RE: Building Survey Summary
Leong Family Dentistry
420 Peninsula Avenue
San Mateo, CA 94401

Hughes Associates, Inc. (HAI) has been retained by Leong Family Dentistry to conduct a building survey to observe the existing conditions of the dental office building, located at 420 Peninsula Avenue in San Mateo, California. The building was surveyed on September 21, 2013 for general compliance with the requirements of the 2010 editions of the California codes, as amended by the City of San Mateo (the Authority Having Jurisdiction, AHJ), and applicable NFPA codes and standards. This letter summarizes our survey observations.

Figure 2 Wheel Chair Lift at South Exit

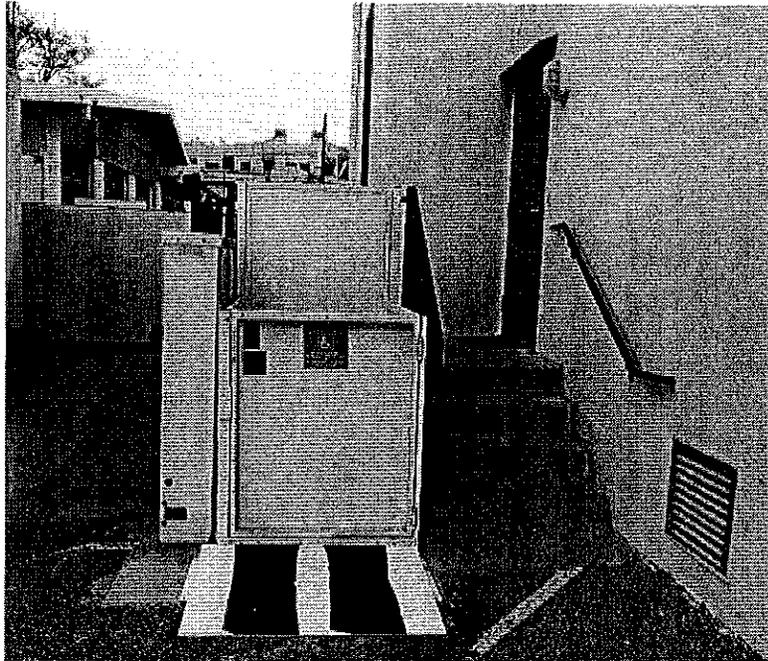
1. The current dental office is provided with two exits. The exit leading to the private parking lot is provided with a wheelchair lift (see Figure 2). As the dental office is classified as a Business occupancy and has an area of 1, 471 square feet, a total of 15 occupants is assumed per the CBC Table 1004.1.1. Therefore, one exit is required. According to CBC Section 1007.1, at least one accessible means of egress is required to be provided. The number of exits and the number of accessible exits meet the code requirements.

Figure 3 Exit Sign at South Exit

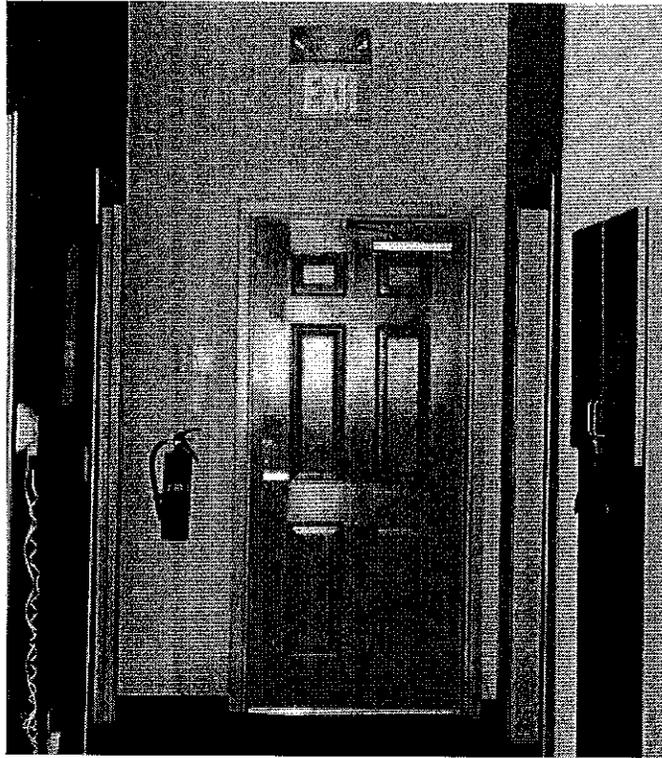
5. Illuminated exit signs are provided throughout the dental office (see Figure 3).
6. Emergency lighting is provided throughout the dental office. It meets the code requirements. It appears that the emergency lights are provided with battery backup power.

Figure 4 Existing Riser

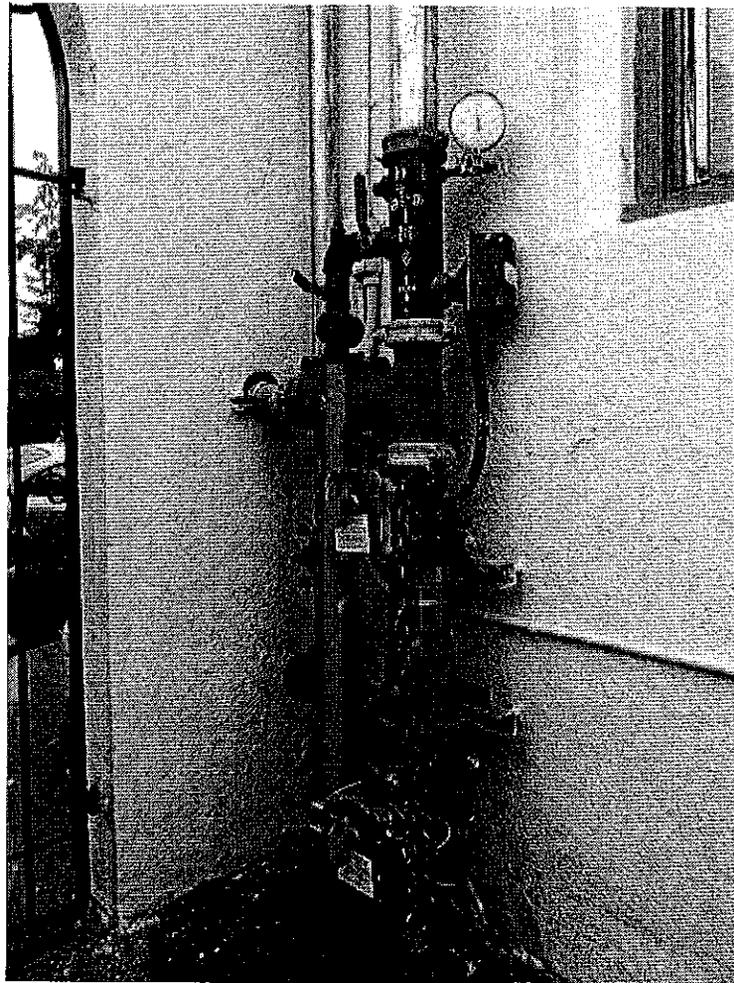
10. The sprinkler system riser is a 3-inch riser located outside near the northwest corner of the building (see Figure 4). The sprinkler riser appears to be galvanized. It appears that the waterflow switch is electrically monitored. The two butterfly valves are not electrically monitored. They are locked in the open position. According to CBC 903.4 and NFPA 13 Section 8.16.1.1.2.1, this is considered acceptable when the system serves less than 20 sprinklers. As the vacant space of this building will be provided with sprinkler protection during renovation, the sprinkler system will serve more than 20 sprinklers. It is required that all valves controlling the water supply to be electrically supervised.
